REFERENCE No. L. M. A. 4950 OF 1928.

MEMO:—

PLAN SHOWING PROPOSED ADDITIONS & ALTERATIONS
TO HOUSE ON PLOT NO. 17 - SHEET J.L.5

With reference to ^{his}~~their~~ application dated 27.3.28 with a plan for the proposed Building additions on plot No. 17. Survey Sheet No. J.L. 5-
 Jail Quarter Mr. Harmandas Anandji is informed that until the following requirements are complied with the plans cannot be passed.

PLAN SHOWING PROPOSED ADDITIONS & ALTERATIONS
TO HOUSE ON PLOT NO 17 - SHEET J.L.5

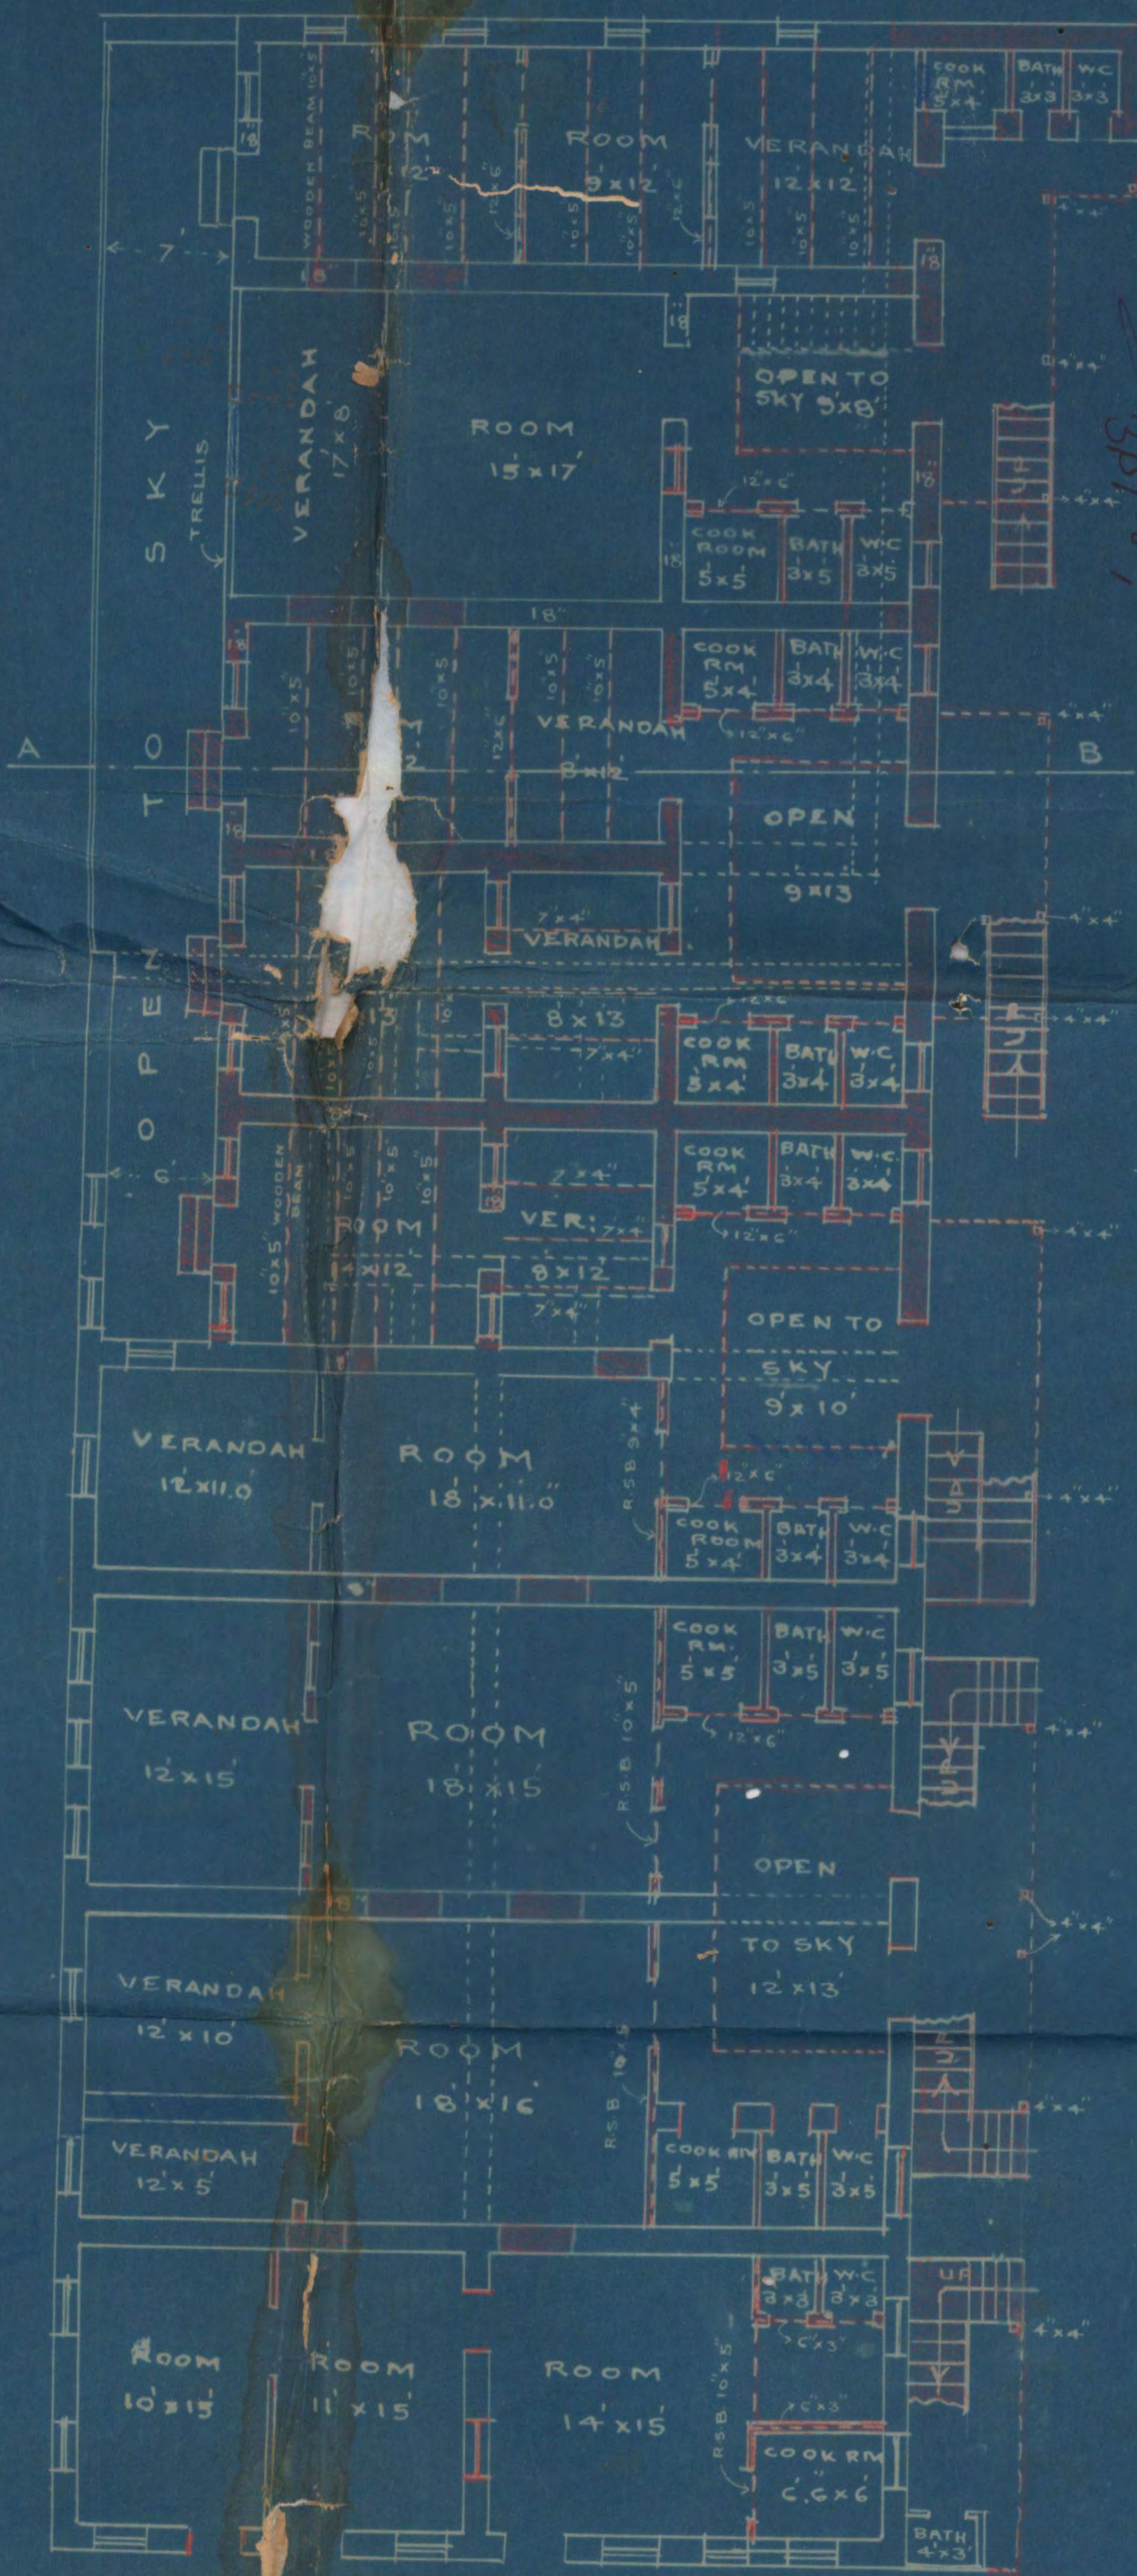
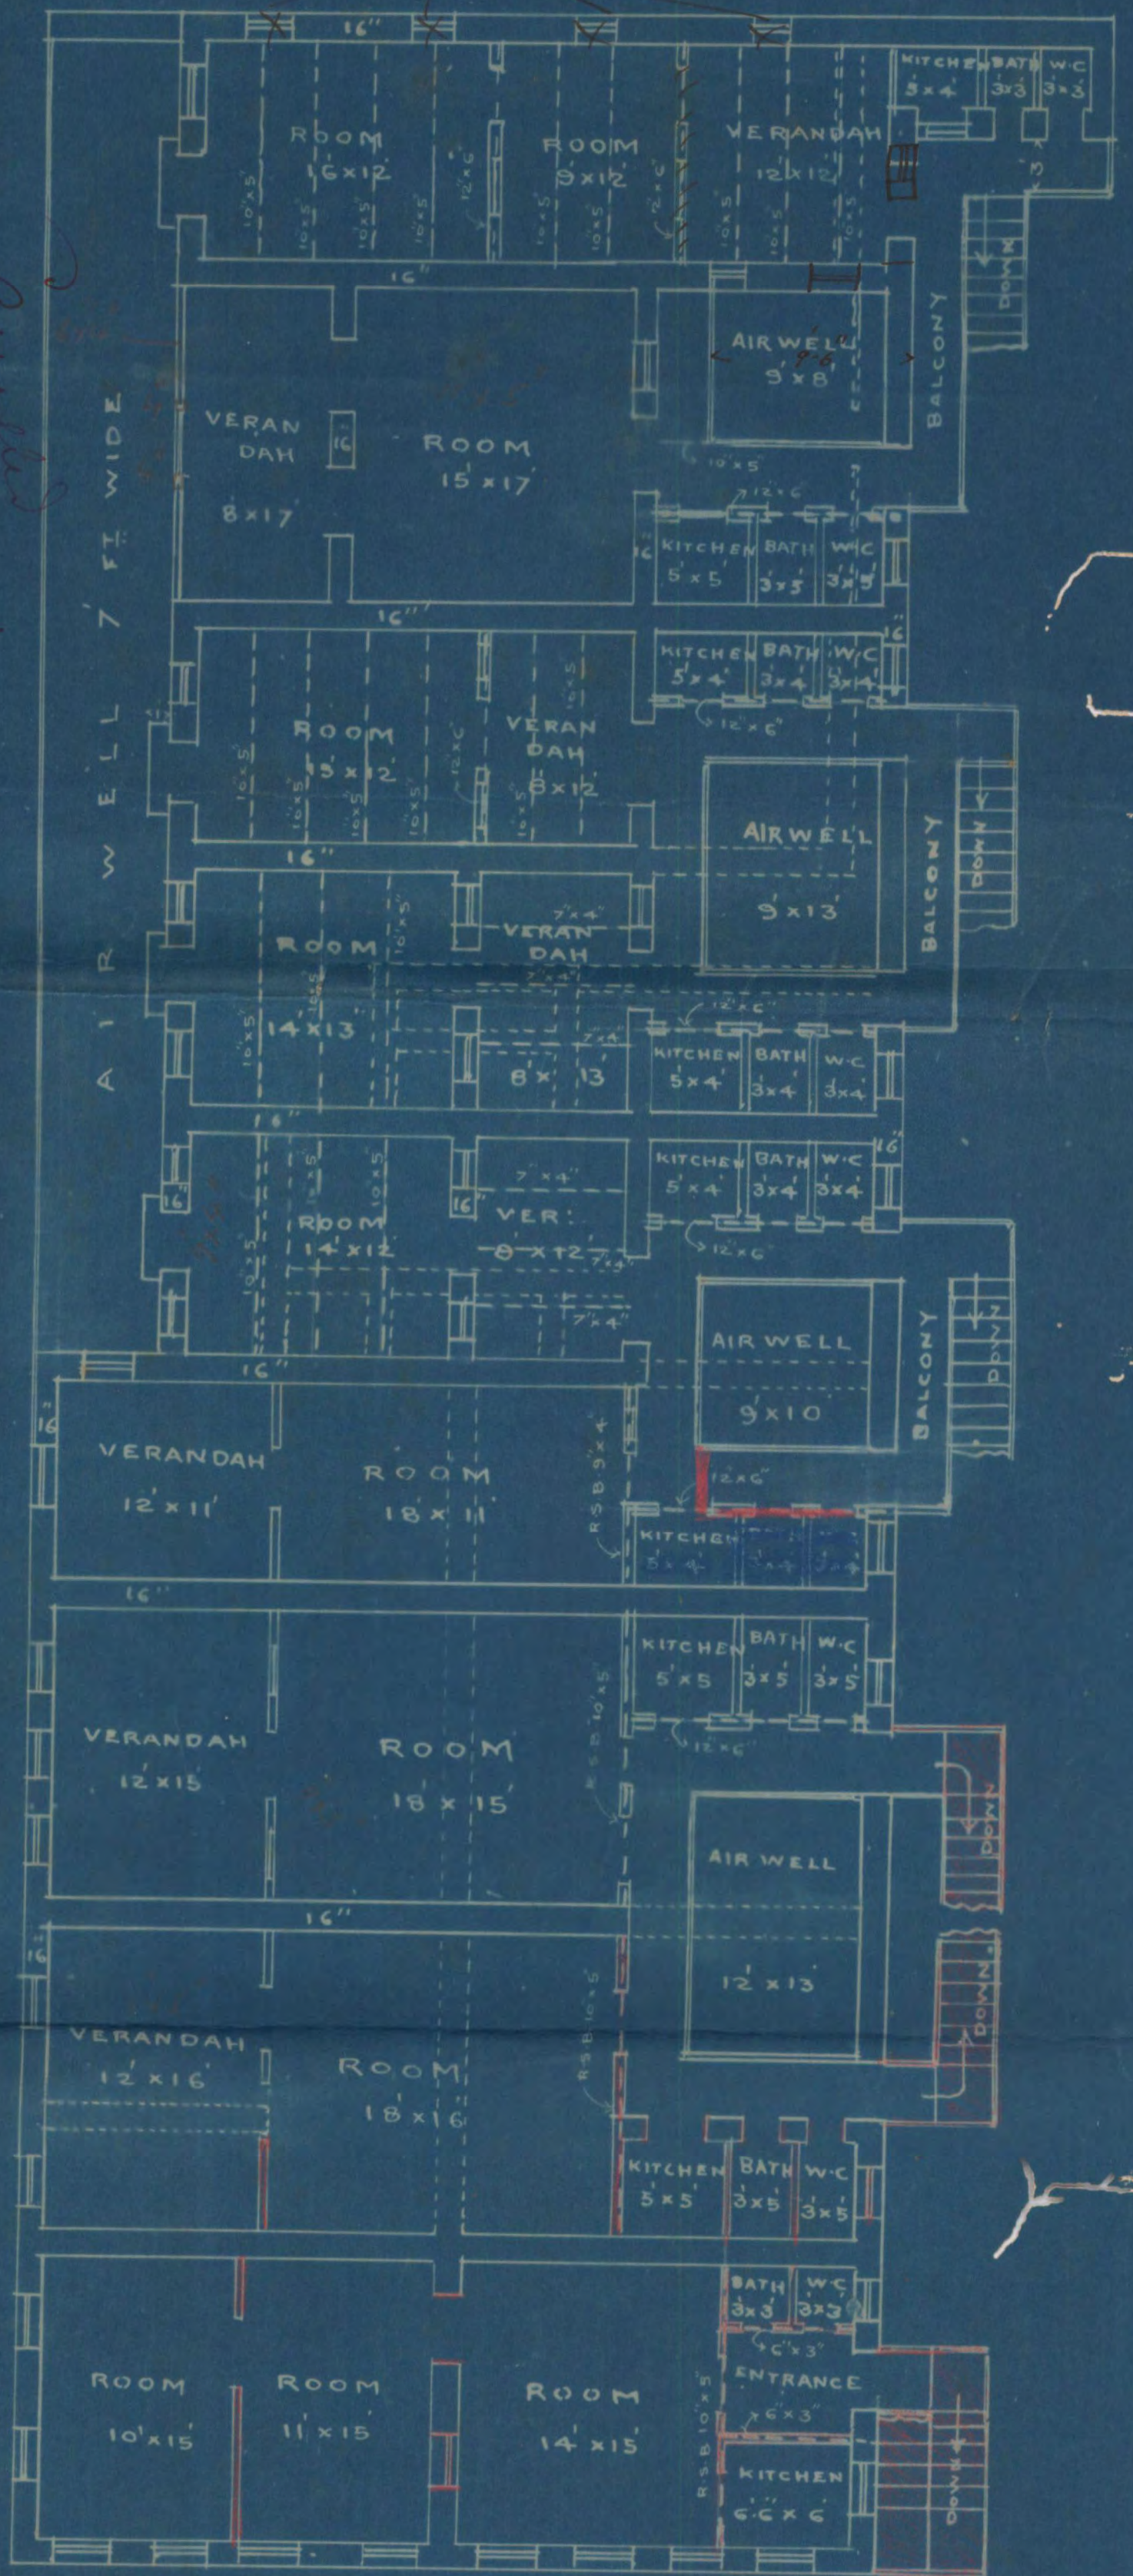
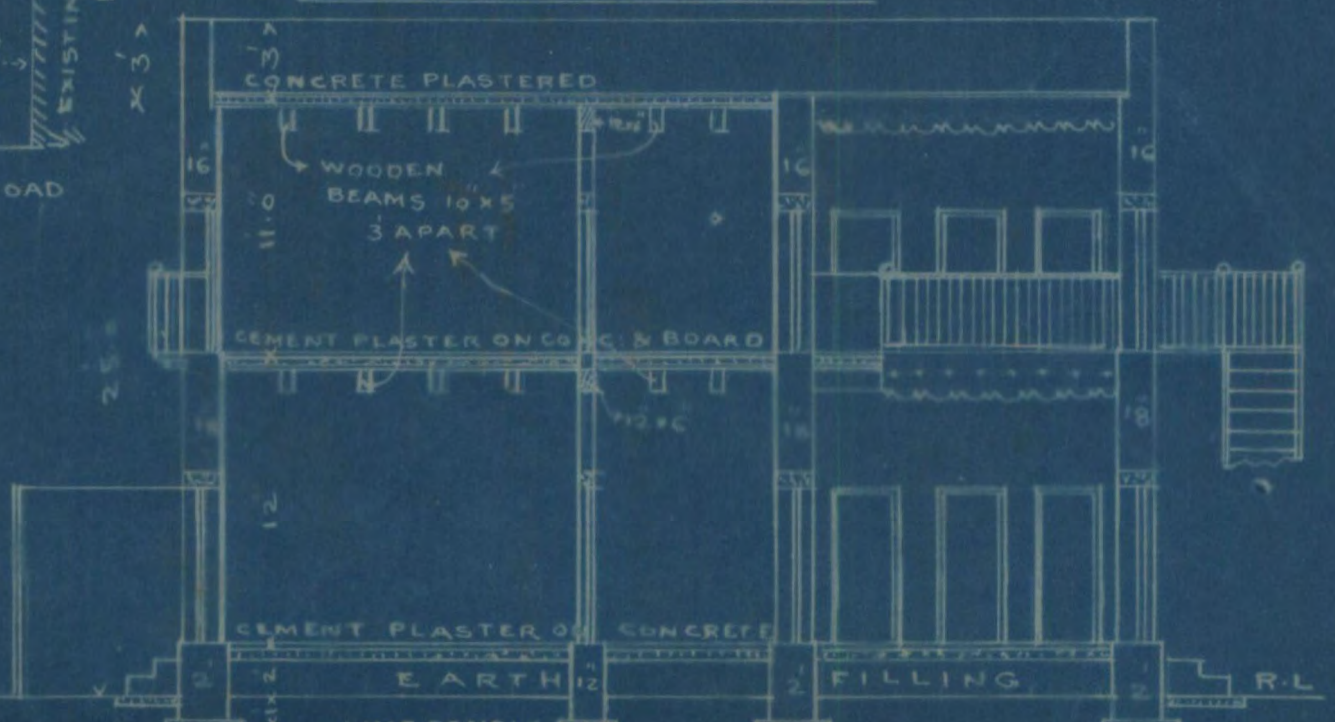
- (1) Foundation of wall B must be exposed. It is 15" in size.
- (2) Existing joint arrangement should be shown where they are to be repaired.
- (3) Windows should be provided at C.
- + (4) Door & window opening should be specified as they exist and as they are proposed.
- + (5) Beam of adequate size to be provided beneath wall A.
- + (6) Size & nature of partitions should be specified.
- + (7) Posts supporting stairs to be 5' x 5' on ground floor and 4' x 4' on 1st floor.
- * (8) Plans should be corrected as per plan deposited in this office returned herewith.
- (9)
